City of Canby

Staff Report
File #: MOD 23-02
FoB Taproom Outdoor Space

STAFF REPORT DATE: June 5, 2023

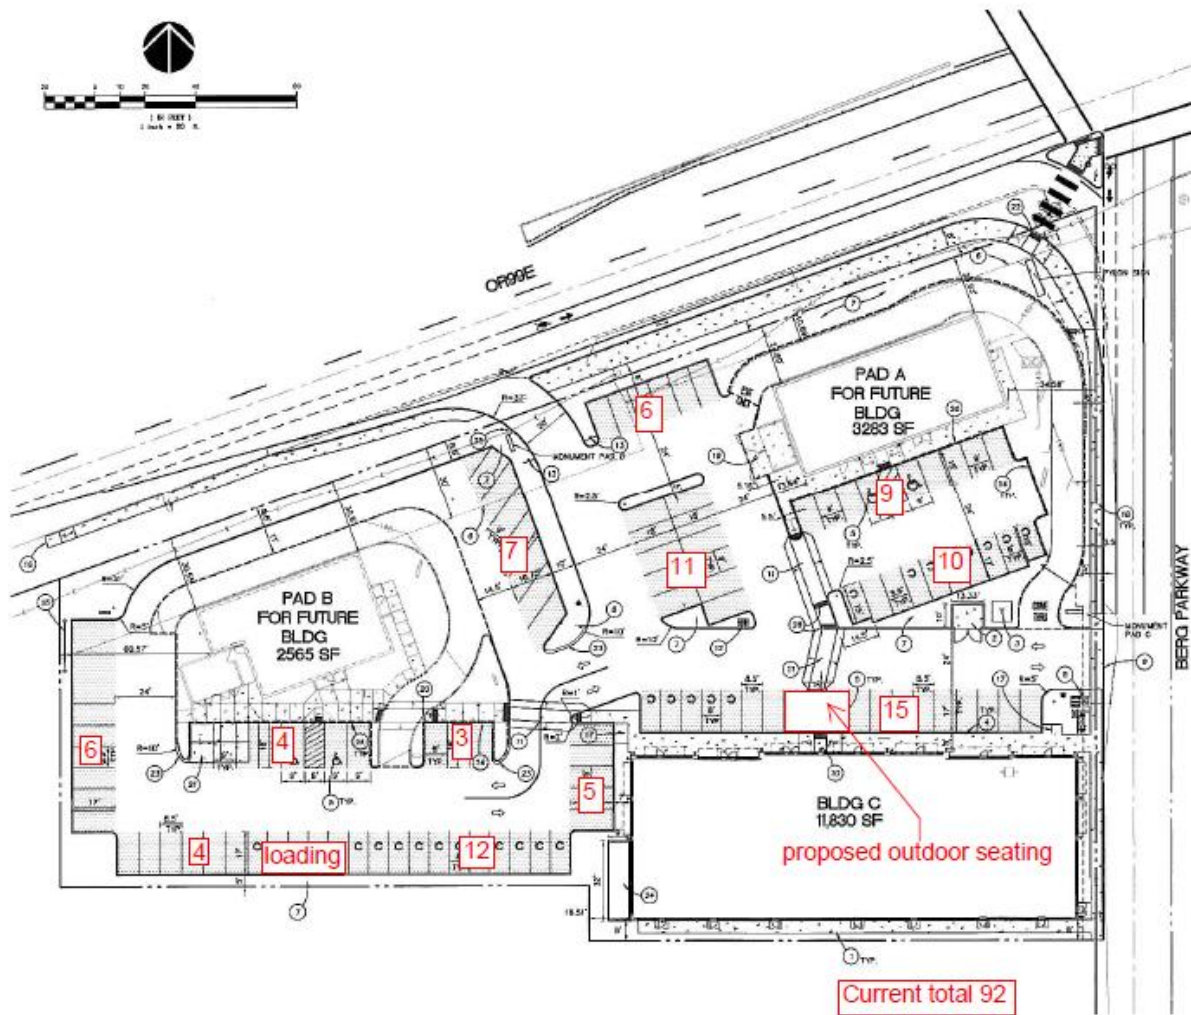
The shopping center currently has 92 functional parking spaces. The shopping center site plan shows 99 parking spaces on site. In the southwestern bank of parking spaces there is an unauthorized loading zone created using paint over the top of 5 parking spaces. This loading zone was never reviewed or approved by the City and must be removed as a condition of approval for this modification (see Condition #1). The parking spaces must be restored in order to meet the minimum required number of spaces for the center, 97 spaces. Two parking spaces are currently occupied by the outdoor space created by FoB under the Open Air Canby program. These are the same two spaces that would be permanently removed to accommodate the proposed permanent outdoor space. These two parking spaces were once ADA parking spaces. The applicant has already relocated the two ADA parking spaces in the complex, their location and configuration has been approved by Clackamas County Building Services. The site plan below shows the parking space count and configuration in the center.

Finding: The property owners of Canby Place Shopping Center have provided a letter acknowledging and accepting their obligation related to the removal of the unauthorized loading area and restoration of the 5 parking spaces in the same location. A Condition of Approval to this effect has been included in this decision. Therefore, staff find the minimum number of parking spaces will be available in the shopping center and find this standard is met.

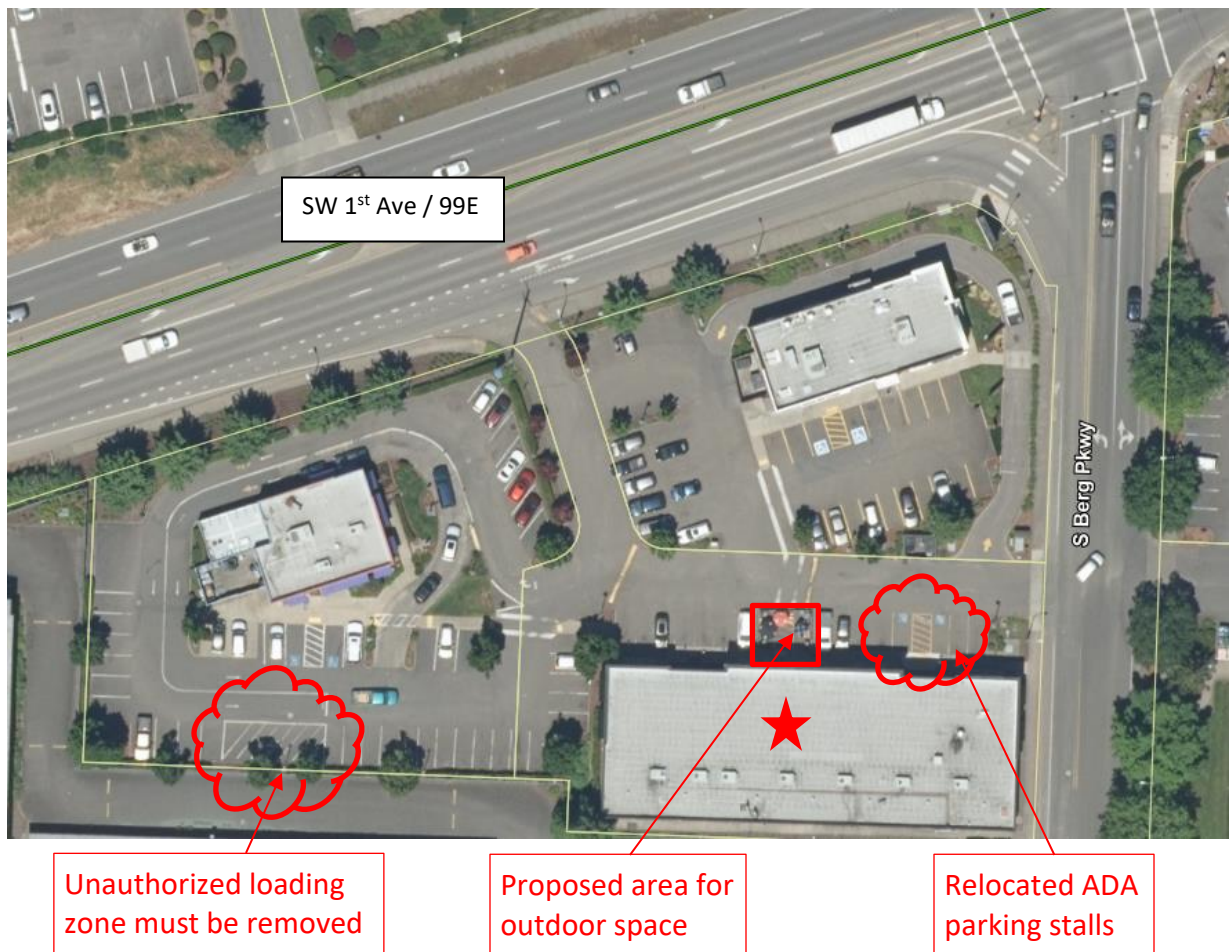
The scope of the proposal includes painting a 25'x17' pad onto the existing asphalt to delineate it as an outdoor customer space, with permanent installation of existing light features and bollards. Tables made of metal and treated wood and potted landscaping will further outfit the space and designate it as separate from the adjacent parking stalls. Renderings of the outdoor space can be found in Attachment A. The drive aisle will not be encroached upon by the bollards, or any accessory items used in outdoor customer space.

Finding: Staff finds the scope of the project will not conflict with any of the site and design review standards found in Section 16.49, including the design elements found in Table 16.49.040, bicycle parking facilities, and landscaping.
